Permit Type: Building/Residential/Misc/Tanks
 Permit Number: B21001469
 Opened Date: 04/30/2021

Description of Work
 SFD/ INSTALL (1) 500 GALLON UNDERGROUND PROPANE TANK

| PROJECT: WINDSOR FOREST KNOLLS LOT 18 | |
| TITLE: ONSITE SEWAGE DISPOSAL PLAN | |

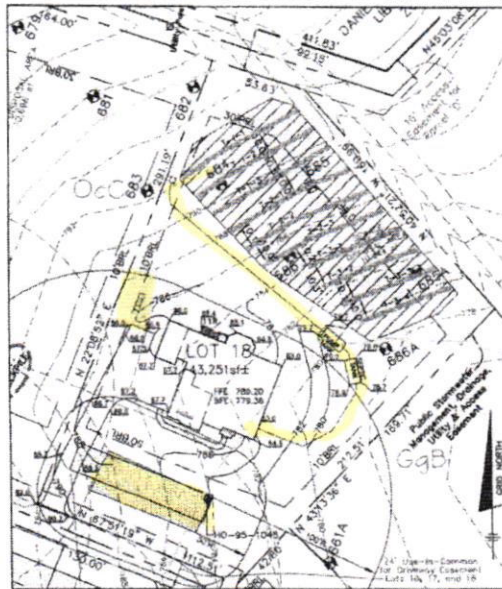
Is the pipe already there or just being proposed? Can it be moved so the flow isn't headed toward the SDA in case runoff overwhelms the pipe?

The building permit site plan for 18423 Hidden Creek Way shows a stormwater outfall/discharge pipe within 25 feet of the SDA. In addition, the pipe crosses over the septic line and it also runs through part of the SDA. Please update the BP site plan and OSDS Plan to meet the 25 ft. setback. Also, the septic profile should show the storm water pipe elevation at intersection of septic line. Lastly, the pipe should not run through the SDA.

Is what you are showing me something from the final plat supplemental that's already been approved? I wonder if they can move the whole thing so that it runs where the house is going instead. If it s a solid pipe laying above the ground, that is good, but it would be better if we can move the whole thing so that the flow isn't headed toward the SDA if runoff overwhelms the pipe. It is a 12", so there is safety there, but I don't love the idea of putting a dike and channeling a drain above the SDA

Kevin and I were just discussing this temporary slope drain shown on the BP site plan for 18423 Hidden Creek Way (See attachment). The engineer states, "what you see is a temporary slope drain, to convey the offsite runoff from the earth dike to below the septic field. It lies on the surface, and causes no disturbance to the SDA". We were just wondering what you thought about it. Should this hold up BP approval?

okay. They will need to remove it all before septic permit issuance.

I don't know for sure if it's in place, but it will be installed as soon as they get a GP and start the earthwork. The grading plan has been approved, so that could be under way. The pipe is necessarily place in the 'low point' along the top of the lot, which naturally flows down along the SDA. If the pipe was overwhelmed, it would be at the top where the swale dips down, and the flows would ruin through

Hank - what you see is a temporary slope drain, to convey the offsite runoff from the earth dike to below the septic field. It lies on the surface, and causes no disturbance to the SDA.

I suppose I can buy it with the super silt fence in place to protect the SDA. They will need to remove it all before septic permit issuance.
